Rezoning Transportation Analysis

Petition Number: 2023-134

| Date | Description |
|----------|-------------------|
| 11-21-23 | First Review (NK) |

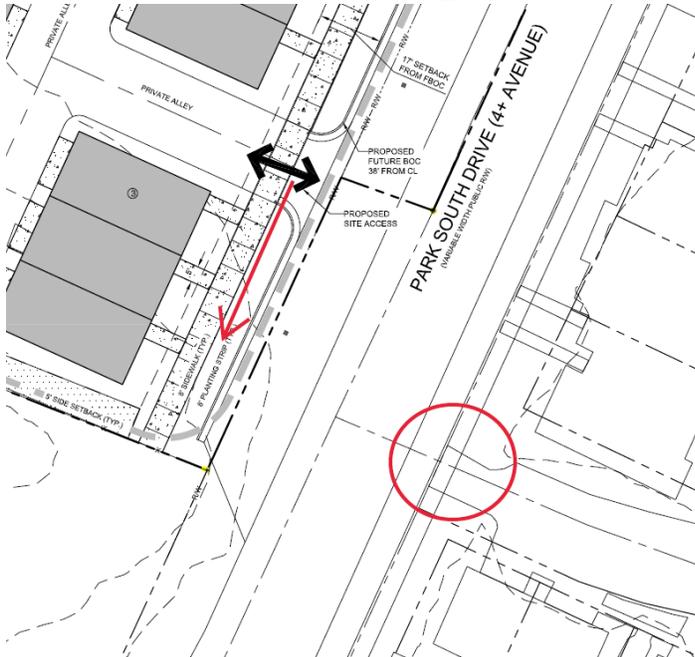
2. Comprehensive Transportation Review (CTR):

A Traffic Impact Study (TIS) is not required for the complete review of this petition due to the site generating site trips under ordinance thresholds found in the Charlotte Streets manual Table 3.1 and/or not triggering any other City TIS requirements.

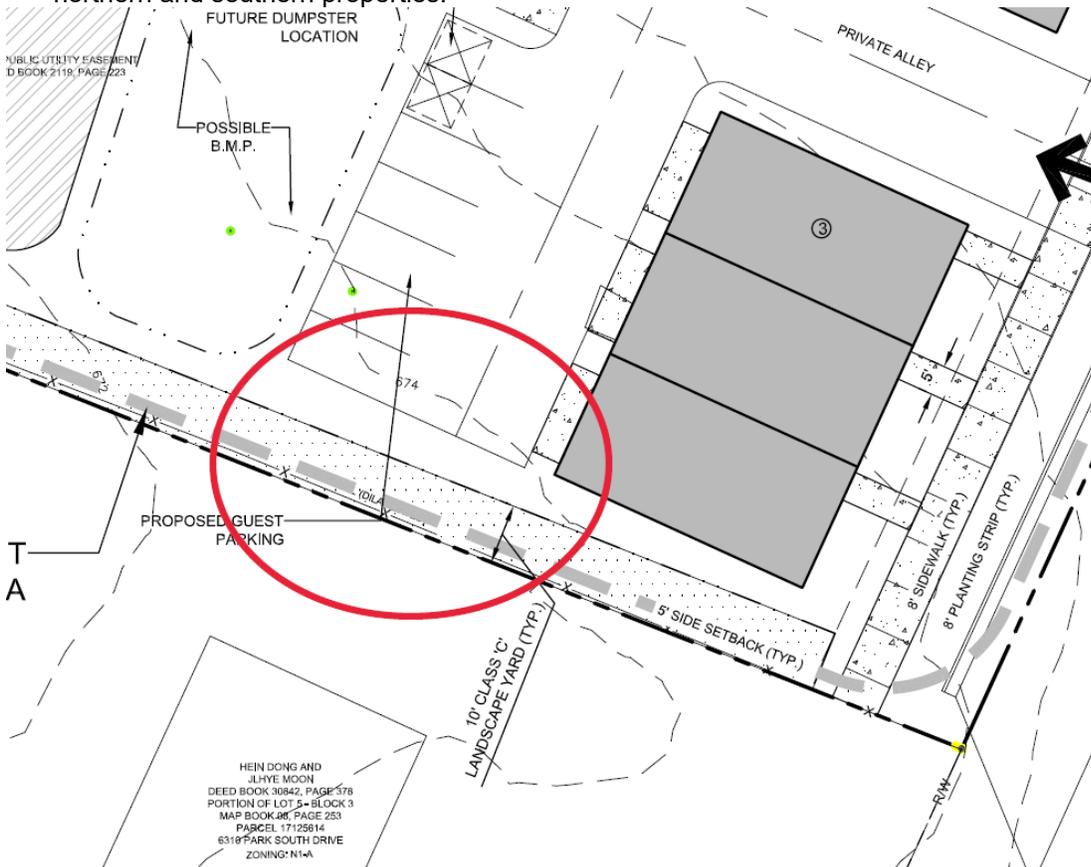
3. Revise site plan and conditional note(s) to commit to dedicate 56' right-of-way from the road centerline. The site plan shall label and dimension the right-of-way from the road centerline.
4. Revise site plan and conditional note(s) to commit to construct bicycle facilities by locating the curb and gutter 38' from the center line.
5. Revise site plan and conditional note(s) to commit to aligning driveway with the driveway located on the opposite property

6. Revise site to commit to a cross access stub connection to the southern abutting property per Article 31 of UDO. Add a conditional note committing to recording a cross-access easement to both the northern and southern properties.
